Design Note

To: Andrew Watt
From: Pedro Vicente
CC: Richard Brown; Dan Bradley
Date: 17/2/2023
Subject: JD Sports Office, Bury – Addendum to FRA & DS report REP-JDS-FRDS-RK-001-REV--
Reference: 211124-NOT-DSGN-JDSP-PVI-REV--

This design note summarizes the findings of the additional percolation testing carried out by Groundtech Consulting on the 18/7/2022, its implications on the proposed drainage strategy as set out in the FRADS and the proposed amendment to the drainage strategy approach for the site.

PROPOSED DRAINAGE LAYOUT

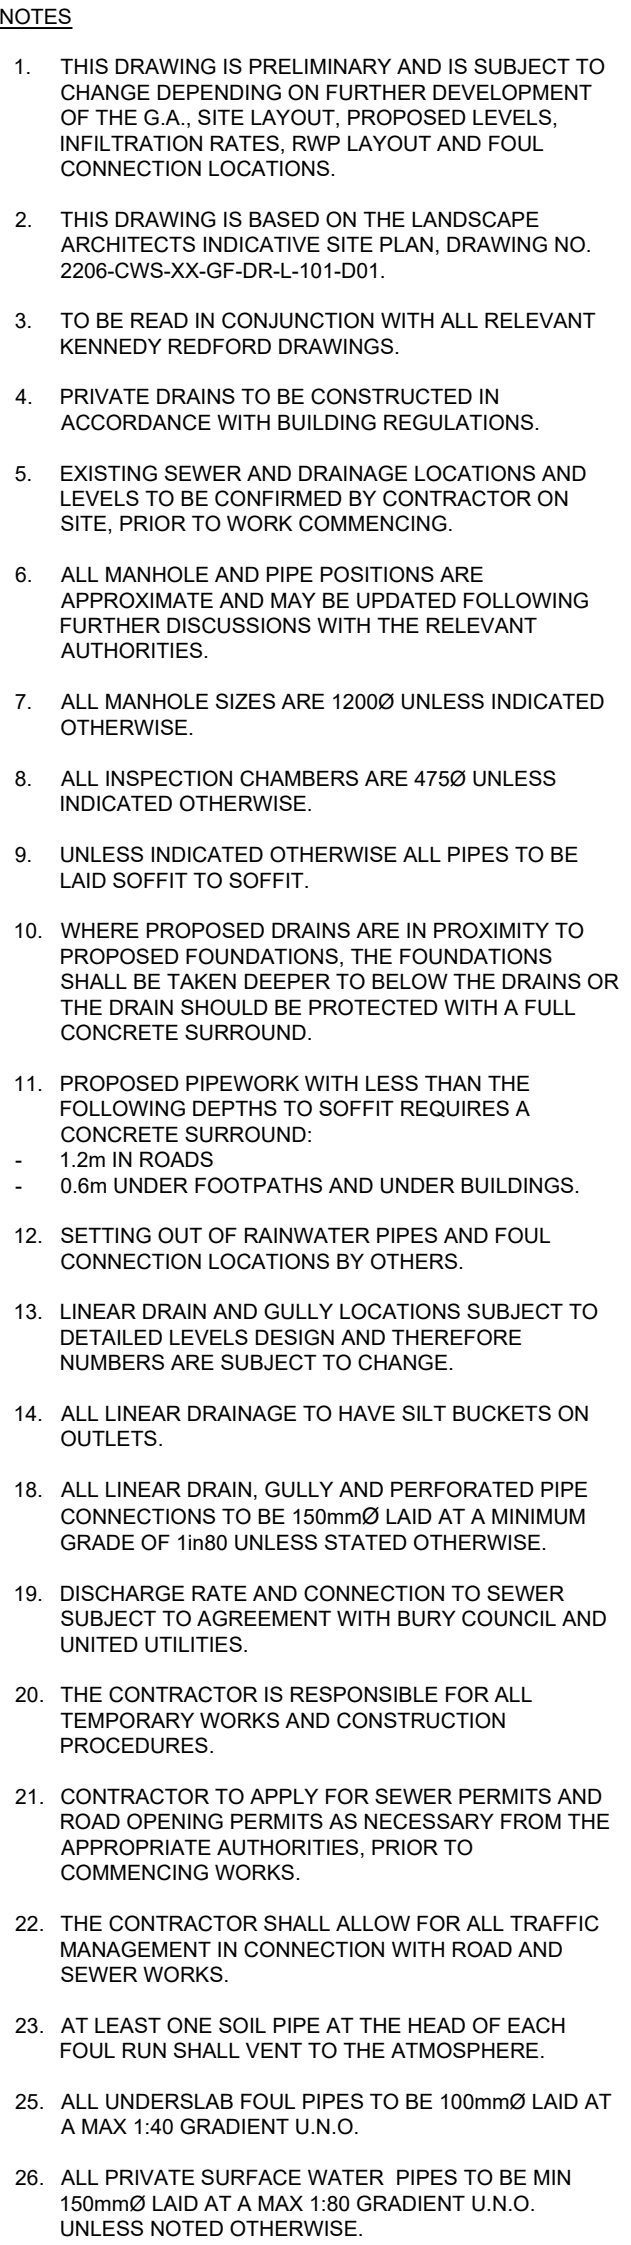
As consequence of the poor results achieved by the percolation testing, the discharge principles for the drainage strategy at the proposed development will now require a positive discharge off-site. Additionally, lime stabilization is proposed across the site to improve the ground conditions in preparation for the development. This will therefore further limit the permeability of the ground.

Considering that the drainage strategy now proposes a positive discharge into a sewer, it is deemed suitable to propose a 70% reduction of the calculated brownfield rate, to a 57.9 l/s discharge. This rate will require the approval of United Utilities, however, as it will provide a betterment to the existing conditions it is anticipated that it will not cause flooding issue to the sewer.

P05	17.02.23	DRAINAGE UPDATED, OUTFALLS REALIGNED TO SURVEY INFO	MM	P.V	R.M
P04	31.01.23	SURFACE WATER OUTFALL AND ATTENUATION TANK REVIEWED	MM	P.V	R.M
P03	23.12.22	FOUL POP-UPS AND RWP ADDED TO CRECHE BUILDING	MM	P.V	R.M
P02	13.10.22	STRATEGY UPDATED	R.B	P.V	R.M
P01	10.05.22	PRELIMINARY ISSUE	R.B	D.B	R.M
REV	DATE	DESCRIPTION	DRN	CHK	APPR
